MEMORANDUM

Subject: Approval of floorplans

The Volusia County Transform386 Single Family Repair and Replacement Program, aka Homeowner Recovery Program, in conjunction with its implementation vendor, LEMOINE Disaster Recovery, is proposing authorization of the following to the available floorplans offered through the program:

EGRET

02 FLOOR PLAN (STANDARD)
OPTION 1

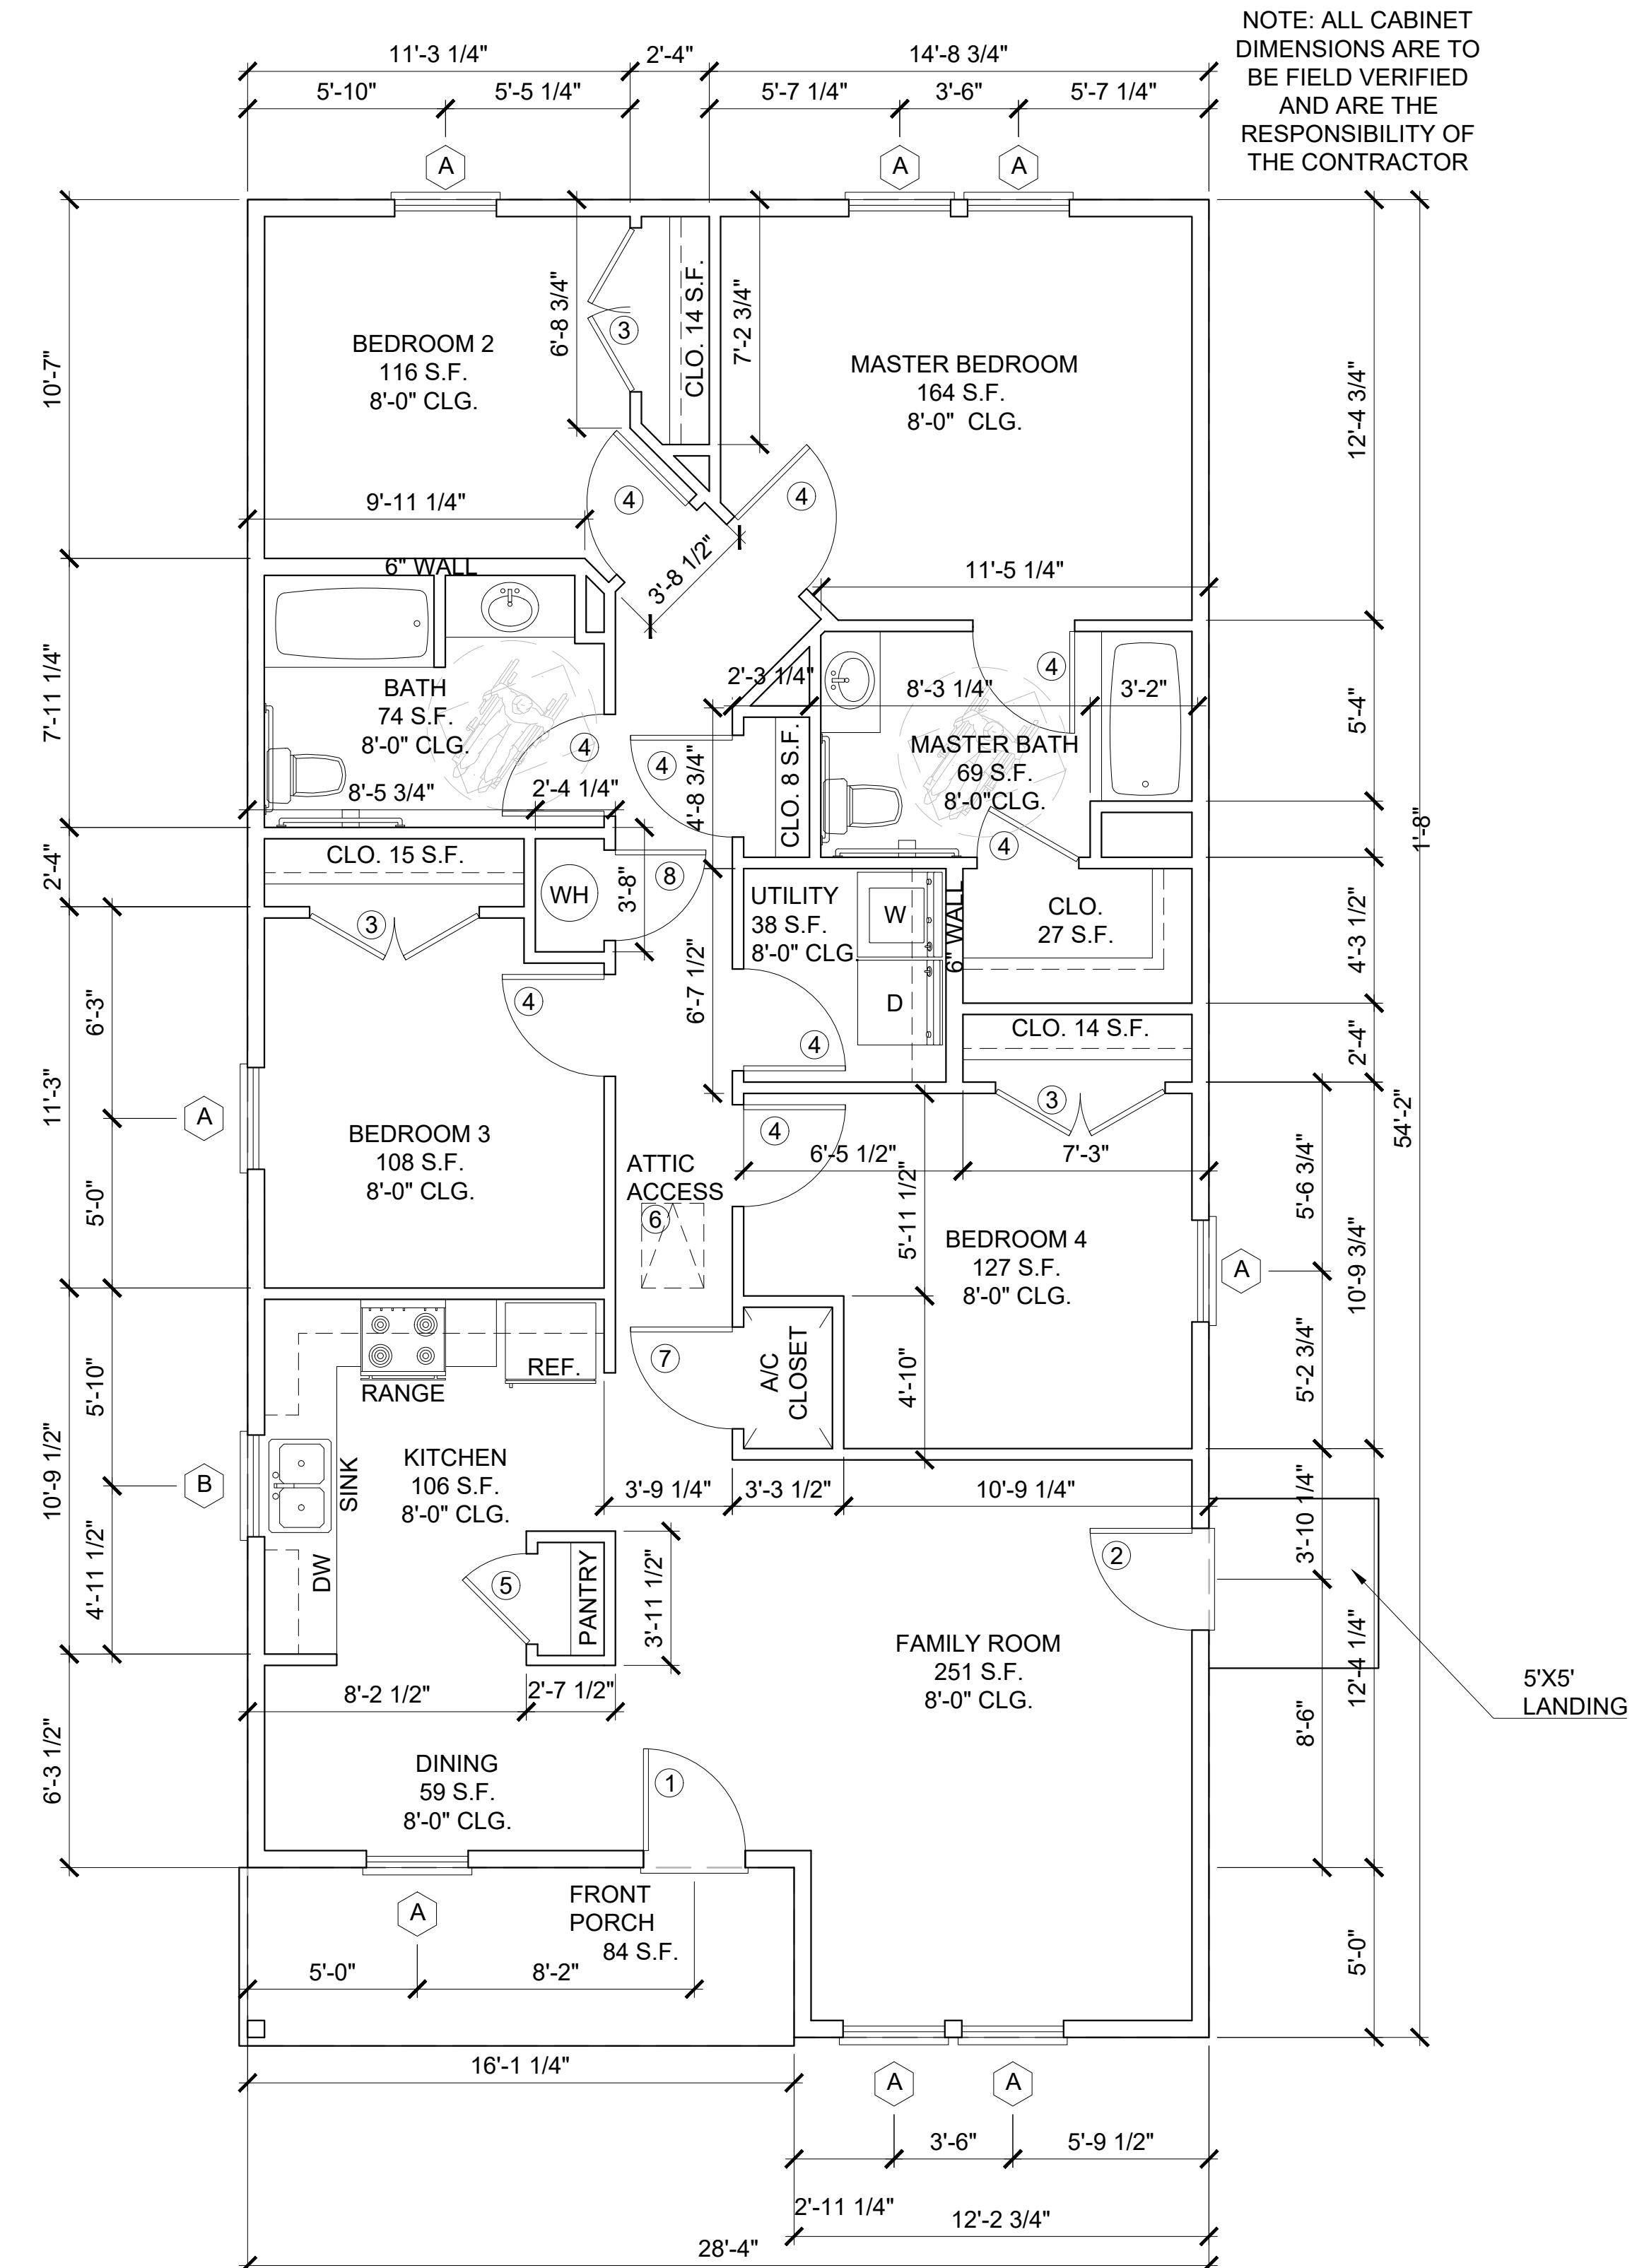
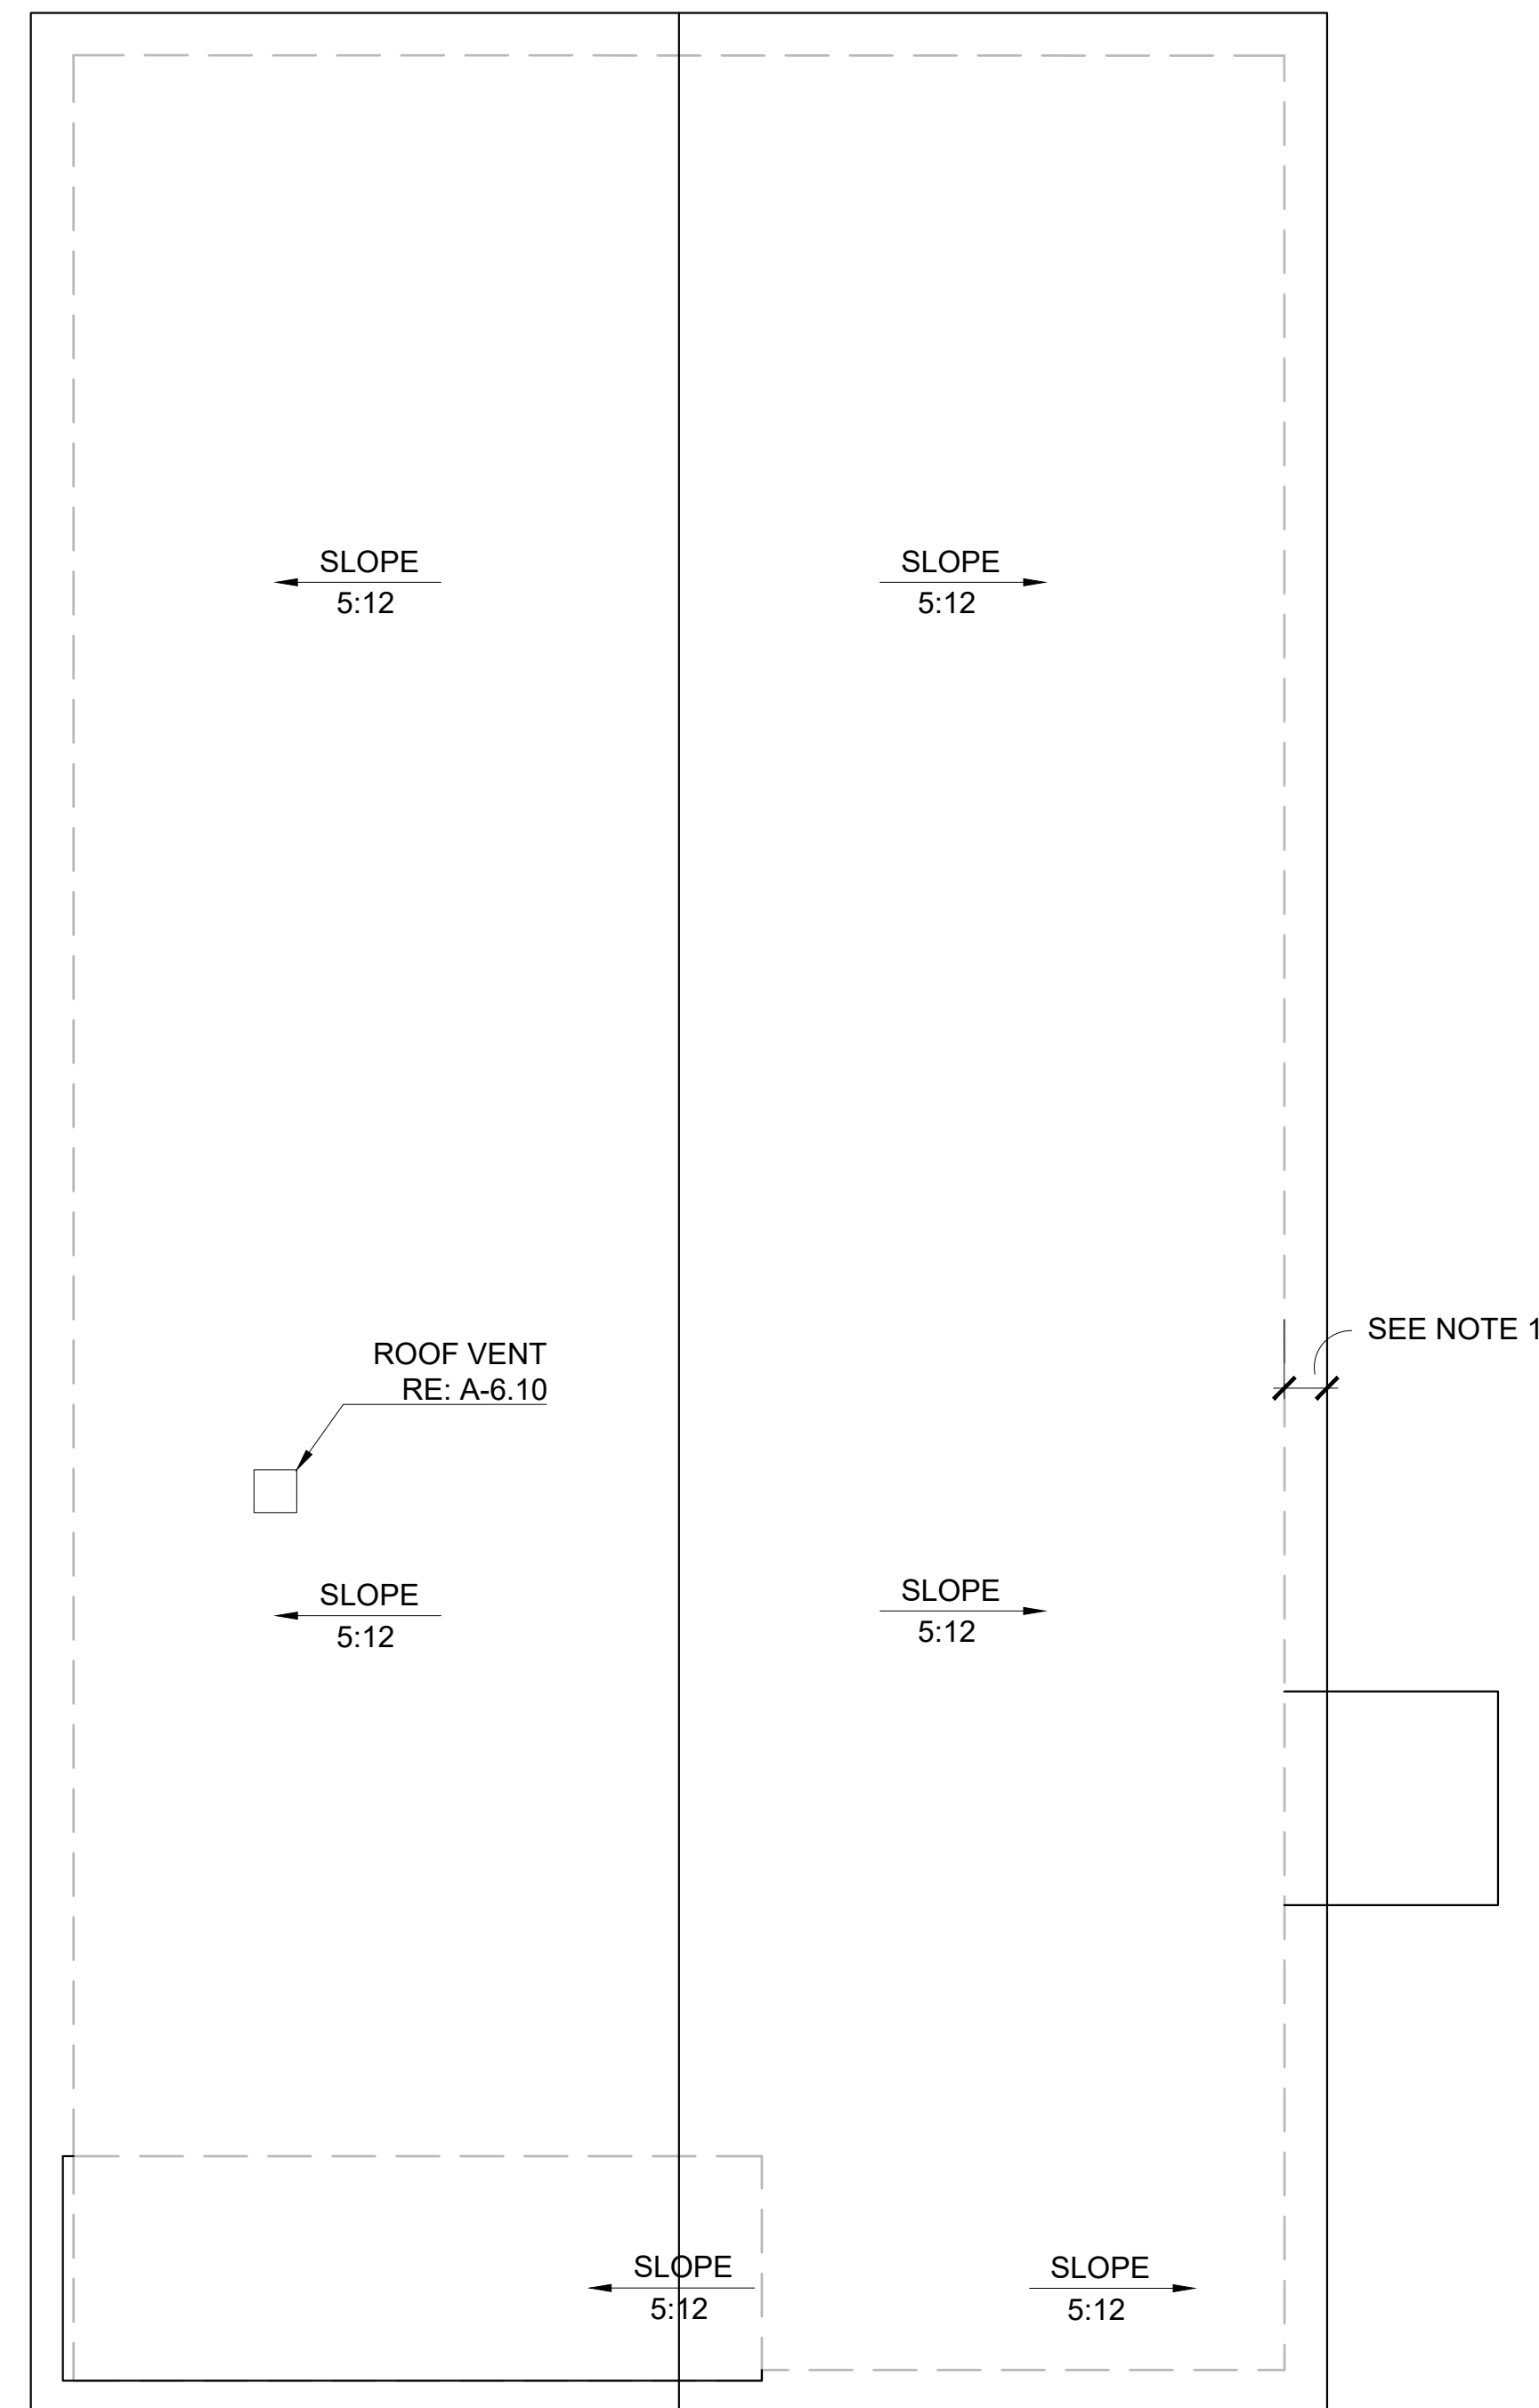
- Add the revised 1454 sq ft 4 bedroom / 2 bathroom Egret plan at a cost of \$287,042 for

Additionally, this memo serves to adjust the cost for the 1215 sq ft 3 bedroom / 2 bathroom "Option 1" shotgun style plan from the March 25, 2026 floorplan approval memo from \$267,157 to \$270,495 to account for cost on the correct square footage.

SQUARE FOOTAGE CALCULATIONS		
LOCATION	SQUARE FOOTAGE	REMARKS
FLOOR PLAN	1,454 SQFT	
FRONT PORCH	86 SQFT	
LANDING	25 SQFT
